REMARKS / ARGUMENTS

Inventor: Frank Messano
AMPHIBIOUS RECREATIONAL VEHICLE
Replacement Sheet
Drawing Sheet 8 of 8

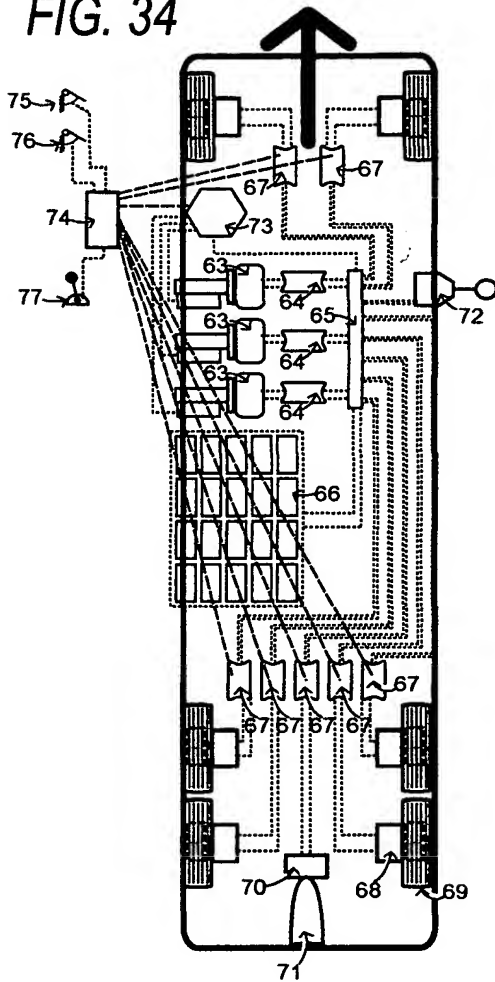
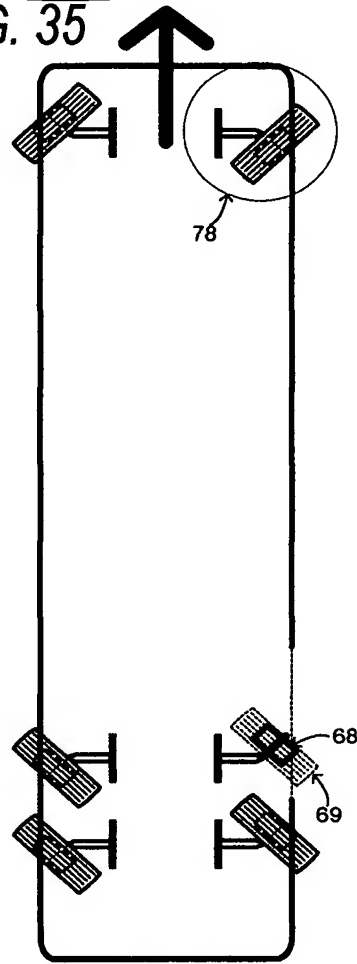
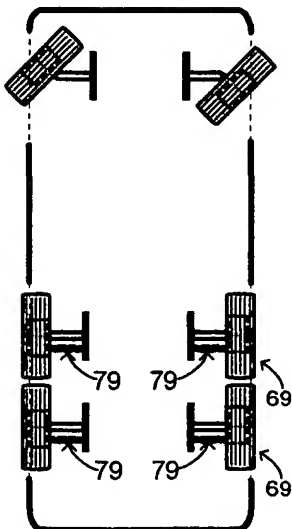
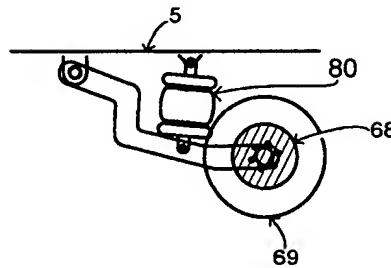
On Drawing Sheet 8 of 8, the heading was changed in response to **Office Action Item 2**.

TITLE changed
w/ words
Replacement
Sheet
